## **ARNOLD SUBDIVISION**

Engineering Comments: The following comments should be addressed prior to submitting the FINAL PLAT for acceptance and signature by the City Engineer:

APPLICATION NUMBER 8 DATE March 5, 2015

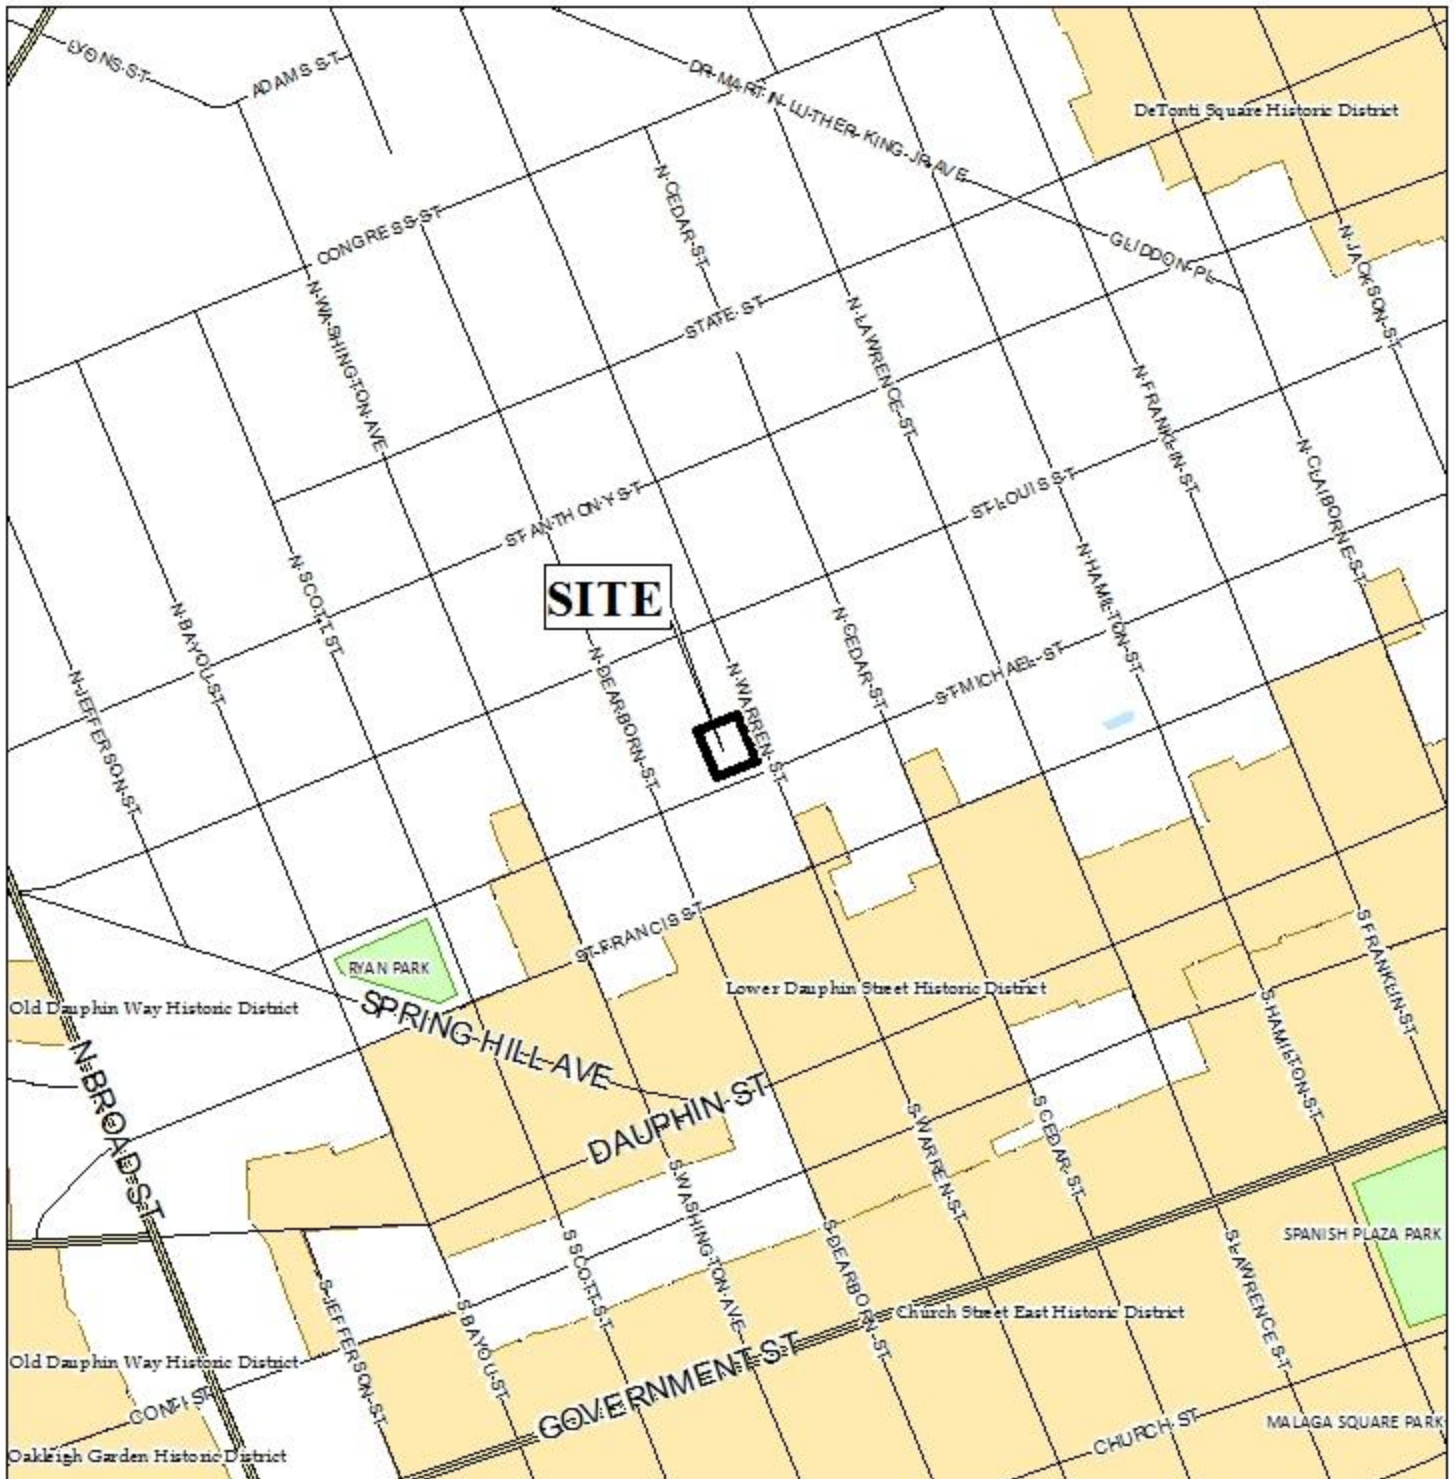
The plat illustrates the proposed 0.2± acre, 1-lot subdivision which is located on Northwest corner of St. Michael Street and North Warren Street, and is in Council District 2. The applicant states that the subdivision is served by both public water and sanitary sewer.

The site has frontage onto two streets: St. Michael Street and North Warren Street. Both streets are considered minor streets, and both meet the minimum right-of-way width of 50 feet for streets with curb-and-gutter.

The site currently has two curb-cuts onto North Warren Street, and one curb-cut onto St. Michael Street. It should be noted that the Zoning Ordinance allows one curb-cut per street frontage within the Downtown Development District. The size, design and location of all curb-cuts that will remain, be modified or added should be coordinated with Traffic Engineering, with all unused curb-cuts to be removed during site redevelopment. All new or modified curb-cuts should conform to AASHTO standards and the Downtown Development District requirements.

The 25-foot minimum building setback line, required in Section V.D.9., is not shown on the preliminary plat. As the site is located within the Downtown Development District, which has no minimum building setbacks, it is recommended that the Commission consider waiving Section V.D.9.

The proposed lot size is not depicted on the preliminary plat. The Final Plat should depict the lot size in square feet and acres, if approved.

Based upon the preceding, and with a waiver of Section V.D.9. of the Subdivision Regulations, the application is recommended for Tentative Approval, subject to the following conditions:

- 1) placement of a note on the Final Plat stating that the lot is limited to one curb-cut per frontage with size, design and location of all curb-cuts that will remain, be modified or added should be coordinated with Traffic Engineering, with all unused curb-cuts to be removed during site redevelopment.;

- 2) placement of a note on the Final Plat stating that all new or modified curb-cuts shall conform to AASHTO standards and the Downtown Development District requirements;

- 3) the labeling of the lot with its size in square feet, or placement of a table on the plat with the same information;
- 4) compliance with Engineering comments, as applicable (*The following comments should be addressed prior to submitting the FINAL PLAT for acceptance and signature by the City Engineer: A. Provide all of the required information on the SUBDIVISION PLAT (i.e. signature blocks, signatures, certification statements, written legal description, required notes, legend, scale, bearings and distances) that is required by the current*
